NOTICE OF DECISION

DECISION OF THE PLANNING ADMINISTRATOR

MODIFICATION OF CONDITIONAL USE PERMIT / CLASS 3 SITE PLAN REVIEW / CLASS 2 ADJUSTMENT CASE NO.: CU-SPR-ADJ16-01MOD2

LOCATION: 3000 and 3100 Ryan Dr SE, Salem OR 97301

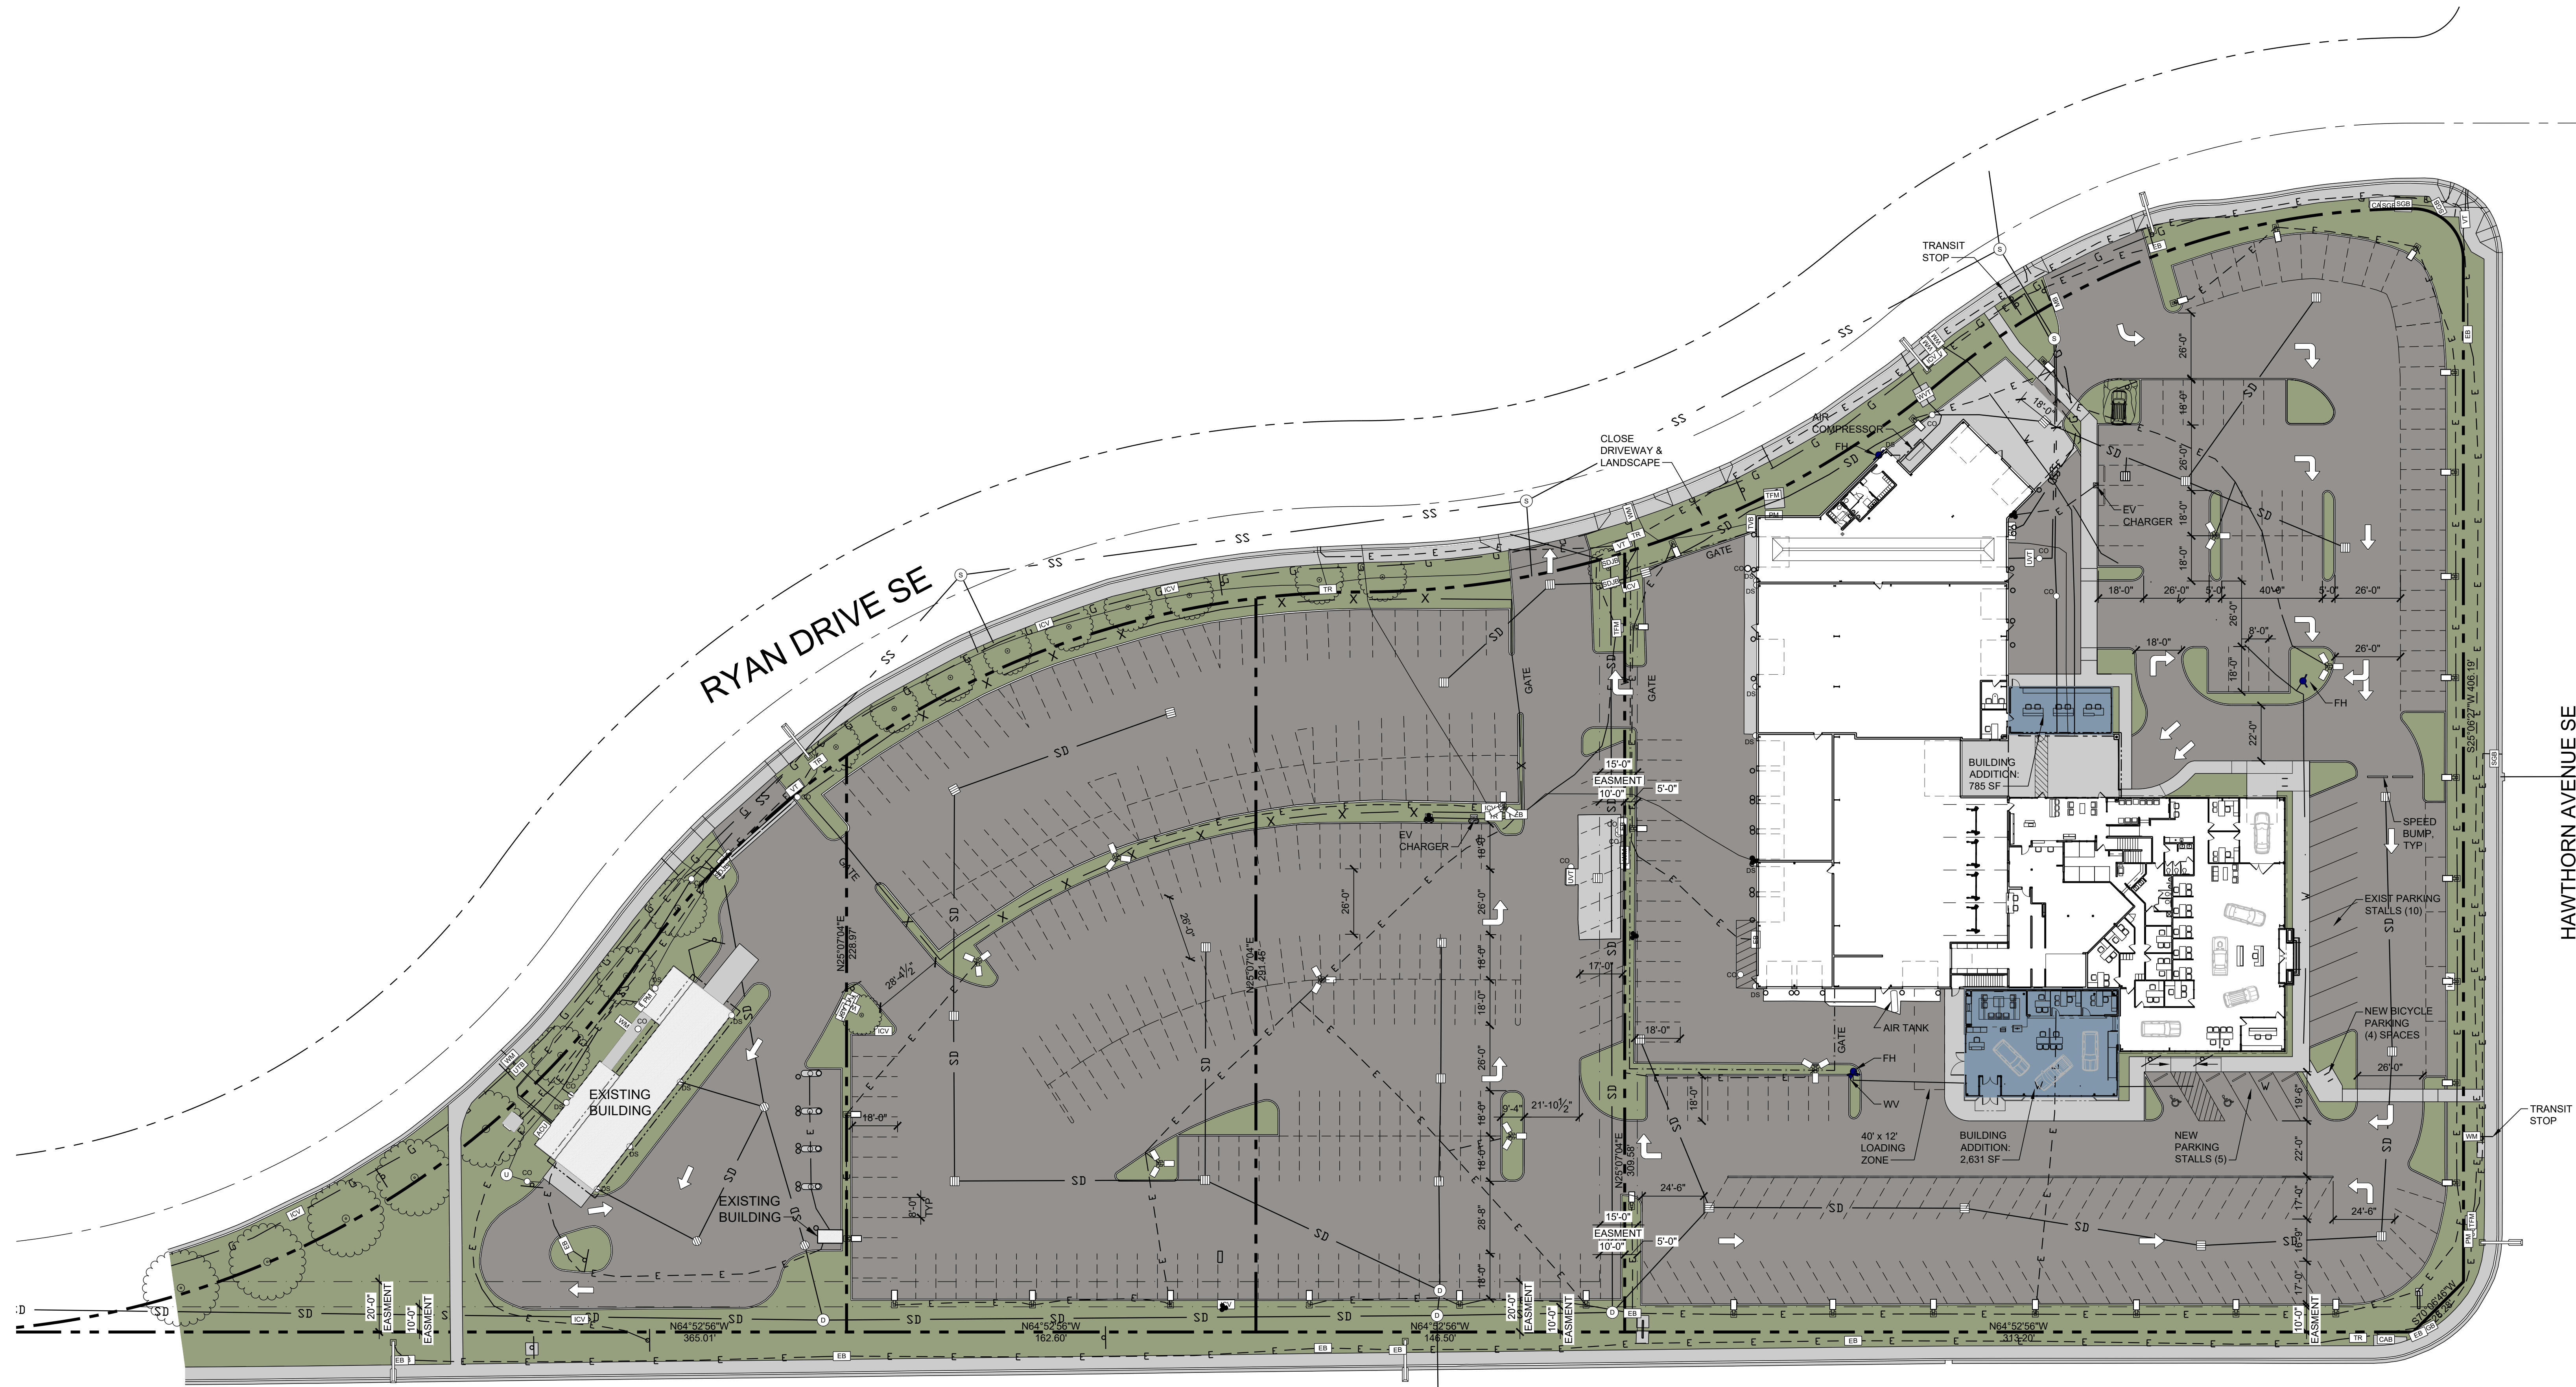
Finding: The applicant's plans indicate the proposed building additions will be setback more than five feet from the street abutting property lines. The proposal includes the reconfiguration of parking and vehicle display spaces to accommodate; but does not propose to expand the existing surfaced area into required setback areas. As such, the standard is met.

Finding The development site is approximately 5.65 acres (246,200 square feet), requiring a minimum of approximately 36,930 square feet of Type A landscaping to be located on the development site. Based on applicants plans, the development site contains 38,147 square feet of landscaping, exceeding the 15% minimum development site landscaping standard. To ensure compliance with SRC 551.010(d)(3), the following Condition applies:

Finding: There are no minimum parking standards for any development within the City. The proposal includes development of two new additions onto an existing *Motor Vehicle and Manufactured Dwelling and Trailer Sales and Motor Vehicle Services* use, which allows a maximum one space per 600 square feet of floor area. Following the addition of the building, the applicant's plans indicate that the floor area of the development site will measure as 36,047 square feet allowing a maximum of 60 off-street parking spaces ($36,047 / 600 = 60$). The proposed development includes reconfiguration of the existing off-street parking area to accommodate the additions, which the applicant plans indicate will result in 15 total off-street parking spaces. The remainder of the site is occupied by existing vehicle display spaces. The proposed parking meets the maximum allowed parking on site.

Finding: The proposed modified parking spaces, driveway and drive aisle for the off-street parking area meet the minimum dimensional requirements of SRC Chapter 806. The 60-degree spaces meet the minimum dimensions for a standard space with the aisle proposed to be a minimum of 22 feet where 18 feet is required. Thus, the parking area dimensions are met.

Finding: The applicant's site plan indicates the total proposed off-street parking area is 2,848 square feet in size; therefore, the additional standards in this subsection area do not apply to the proposed development.

Finding: Two-way driveways are required to have a minimum width of 22 feet. The applicant's plans indicate the existing and modified driveways with a minimum width 22 feet shall be provided throughout the development site.

Finding: The applicant's landscape plan indicates 36,918 square feet of landscaped area is provided for the development site. However, the preliminary landscape plans do not indicate the specific landscaping type or required plant units proposed for each of the landscape requirements, such as setbacks or interior parking lot landscaping. As conditioned under Condition 1, the applicant will be required to provide a full landscaping plan demonstrating that the landscaping meets Type A standard.

Condition 1: At the time of building permit review, a Landscape Plan must be provided demonstrating that a minimum of 15 percent of the development site (approximately 36,930 square feet) is landscaped with Type A landscaping.
